DR-142-1701-831 goes here. Refer to issue #2 on github for more information
FIRECODE Receiver
Sheet: /
File: pyBoard.sch
Title:
Size: A2
Date: MM/DD/YYYY : 10/26/2016
Rev: 1.0
KiCad E.D.A. kicad 4.0.4-stable
Id: 1/1

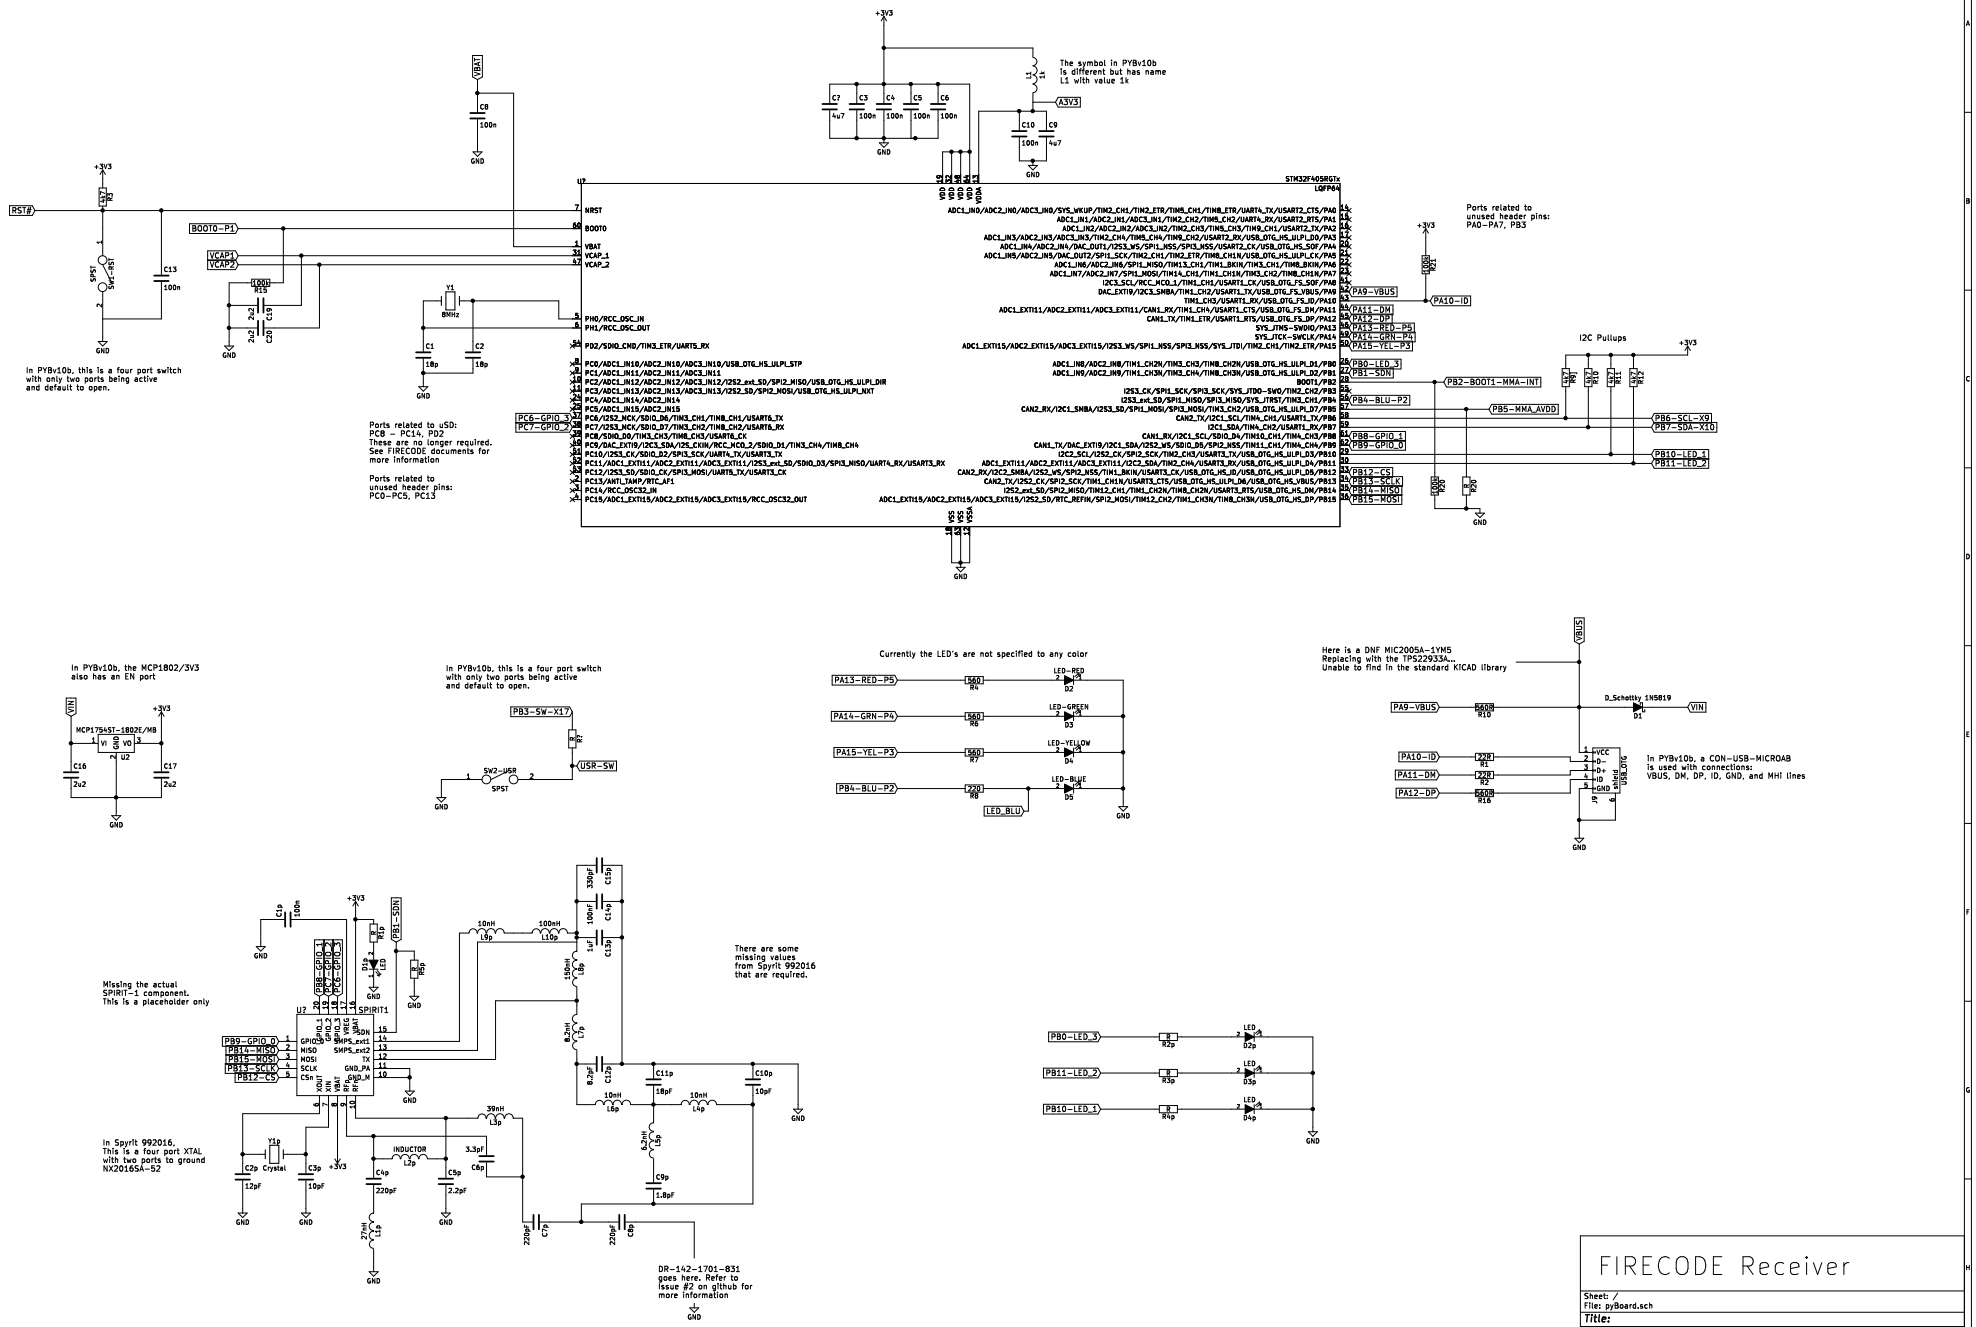
The symbol in PYBv10b is different but has name L1 with value 1k
STM32F405RGTx
LQFP64
Ports related to unused header pins: PA0–PA7, PB3
I2C Pullups
In PYBv10b, this is a four port switch with only two ports being active and default to open.
Ports related to uSD: PC8 – PC14, PD2 These are no longer required. See FIRECODE documents for more information
Ports related to unused header pins: PC0–PC5, PC13
In PYBv10b, the MCP1802/3V3 also has an EN port
Currently the LED's are not specified to any color
Here is a DNF MIC2005A-1YM5 Replacing with the TPS22933A... Unable to find in the standard KICAD library
In PYBv10b, a CON-USB-MICROAB is used with connections: VBUS, DM, DP, ID, GND, and MHI lines
Missing the actual SPIRIT-1 component. This is a placeholder only
There are some missing values from Spyrit 992016 that are required.
In Spyrit 992016, This is a four port XTAL with two ports to ground NX2016SA-52
